Re: Application for Special Permit/Site Plan Approval – 10 Commerce Blvd. (“Lot 1”)

I am writing to provide the Board with response commentary to comments made by Stephen Meltzer of WBH LLC (the “Developer”) during the October 18, 2023 Planning Board Meeting.

Figure 1: Lot 1 elevation as the Potential Future Easement abuts Turnpike's property

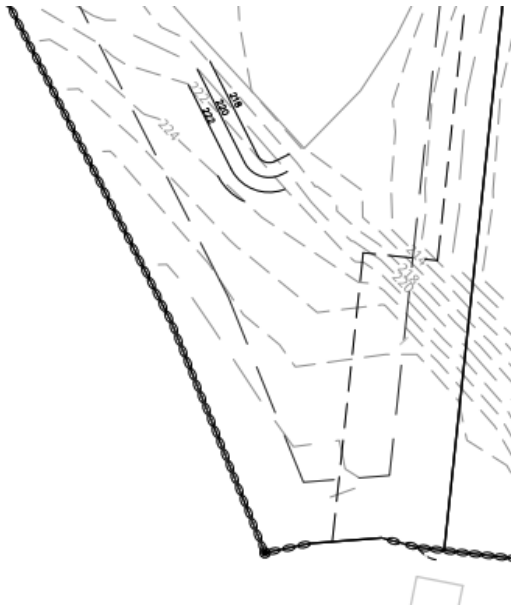
This size and location poses several potential challenges. There is a significant elevation of over 20 ft between Commerce Blvd and Turnpike along the lot line, mostly concentrated in a steep incline close to the lot line. The elevations shown in Figure 1 are from the site plan for Lot 1.

For this to be a usable driveway for Turnpike, it would need to include significant investments in infrastructure and maintenance including retaining walls on both sides, guard rails, lighting, stormwater systems, snow storage, signage, and other elements.

The Developer should coordinate an access plan with Turnpike that incorporates the necessary infrastructure and maintenance plans and provides similar access to what Turnpike has now.

Figure 2: The Red marker shows how far away the Potential Future Easement is to Turnpike's current customer operations, and this wooded area is separated from customer parking by a locked gate.

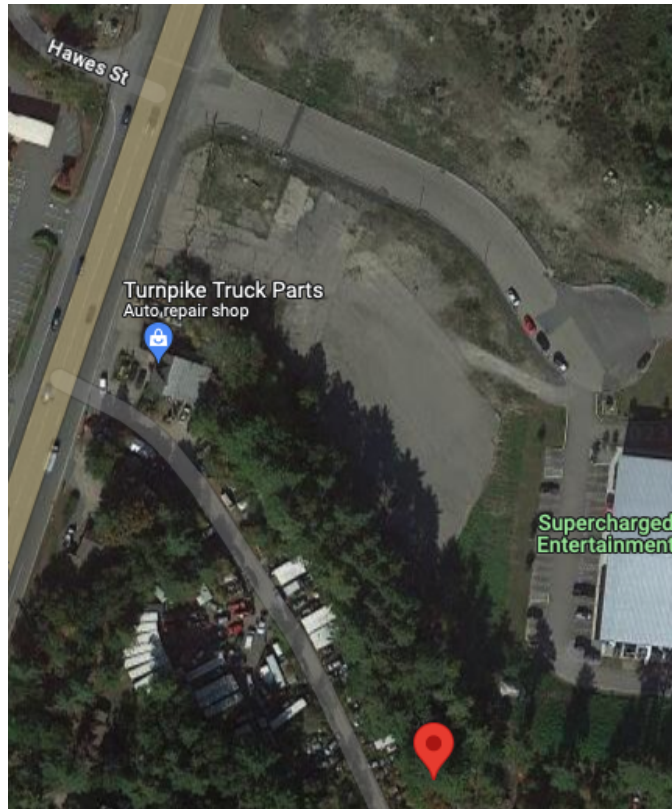
It should also be coordinated and incorporated into Turnpike's current business and the rental properties. The area adjacent to the Potential Future Easement is currently a wooded, storage-only section of our lot that is accessible through a locked, gated entrance and isn't currently accessible from any of the rental properties. Figure 2 shows the Potential Future Easement as it relates to Turnpike's business.
